State of New Mexico
Energy, Minerals and Natural Resources Department

Oil Conservation Division
UIC Program

Copy of Division e-mail correspondence to Apache concerning the use of dual-packer systems in waterflood operations at:

From: Goetze, Phillip, EMNRD
Sent: Wednesday, May 10, 2017 10:10 AM
To: 'Gaines, Dean'
Cc: Brown, Maxey G, EMNRD; Jones, William V, EMNRD; McMillan, Michael, EMNRD; Lowe, Leonard, EMNRD
Subject: Use of Dual Packer System in the WBDU, EBDU and NEDU Waterfloods
Attachments: OCD Example WBDU #137 Dual.pdf

WBDU #137W

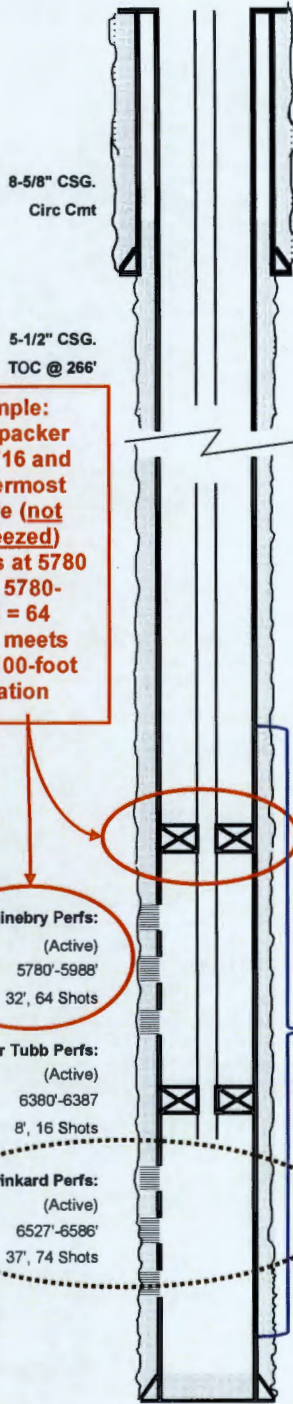
The only compliance issue becomes the "100-foot" setting distance. Using the language in R-12981 [Ordering Paragraph (12) with "*a seal bore assembly set within 100 feet of the uppermost injection perforation*" versus WFX-857 wording of "*packer located within the 100 feet of the injection intervals*"] and after discussion with District personnel who are responsible for UIC inspections, the upper or first packer would be the packer setting to assess compliance with the order. The distance between this packer's setting depth and the uppermost active perforations would be the test for setting within 100 feet (see attachment for example of WBDU #137). The uppermost active perforations will be the Blinebry perfs which are still "active", in this usage – have not been sealed off by casing or squeezed with cement, even though the EOR activities are focused on the deeper Drinkard perforations. So for the example provided with WBDU #137, no exception would be for the 100-foot distance.

Example:
Top packer
at 5716 and
uppermost
active (not
squeezed)
perfs at 5780
feet: 5780-
5716 = 64
feet; meets
the 100-foot
limitation

Summary: Division would approve the use of dual packer assembly (without additional remedial cementing or casing) in all three EOR projects as long as the existing well construction can be used with compromise to the well's integrity and the use is within the limits of the respective Unitized Interval. Where there is an issue with the packer setting and distance to the uppermost perforations, these will be handled on a case-by-case basis with the opportunity for the issuance of Packer Setting Depth Exception letters by Division to resolve these items. Additionally, the Division is recommending the following guidance with dual-packer assembly use:

1. The dual-packer assembly must be set within the defined interval (Unitized Interval) for each respective EOR project. If the upper packer is not within the upper limit of the Unitized Interval, then an exception through an order or letter request must be submitted to the Director (hopefully following discussion between Apache and the Division to review the situation).
2. The MIT requirements [for testing prior to returning to operation] are still in effect if either packer is re-seated or relocated.
3. Apache shall provide a final construction diagram with the installation of any dual-packer assembly approved by District.
